January 15, 2013

RE: Eaglemont Subdivision AP2012-04
Response to SEPA Appeal
SDA Project Number 278-003

Culvert Crossing: TRACT E

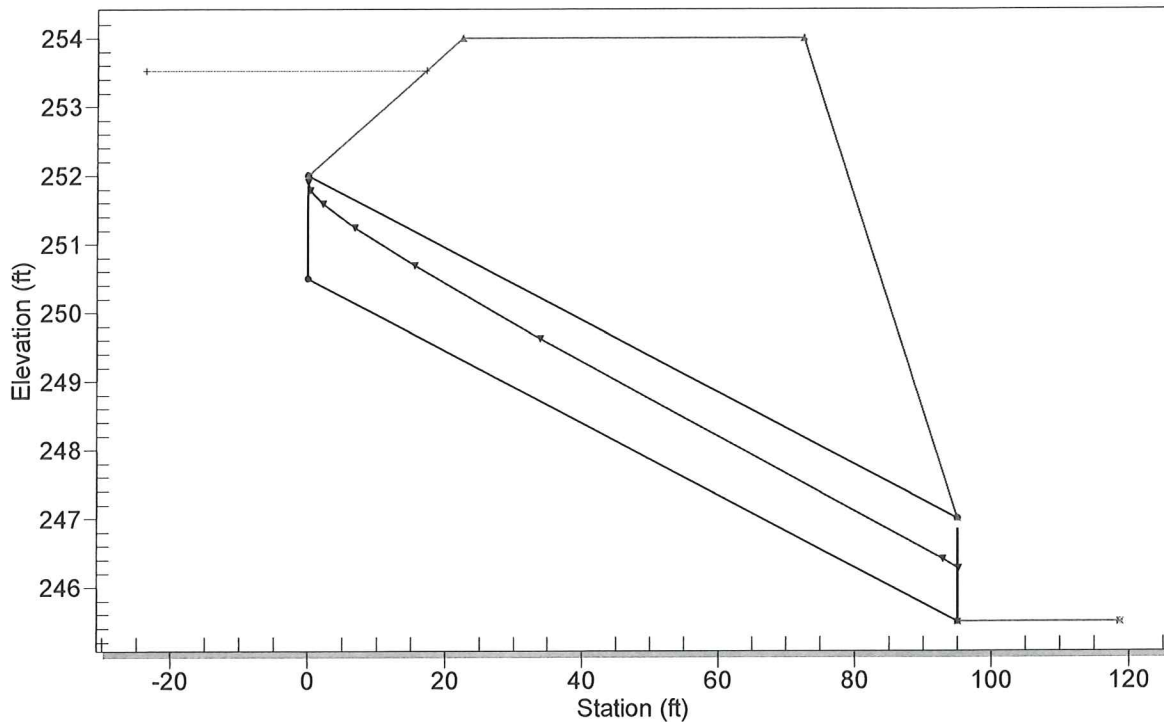
The EO flow is then used in the HY-8 culvert modeling software to test pipe capacity (Appendix C). The existing culvert between Tract 998 and 997 passes 14.13 cfs without any risk of overflowing. The remaining two culverts are not able to pass their corresponding flows in their existing state. It is suggested that these culverts entrances are modified to use a flared end section (Appendix D). This entrance will improve the pipes' inlet performance and will allow them to pass their corresponding EO flows of 14.43 cfs and 14.51 cfs.
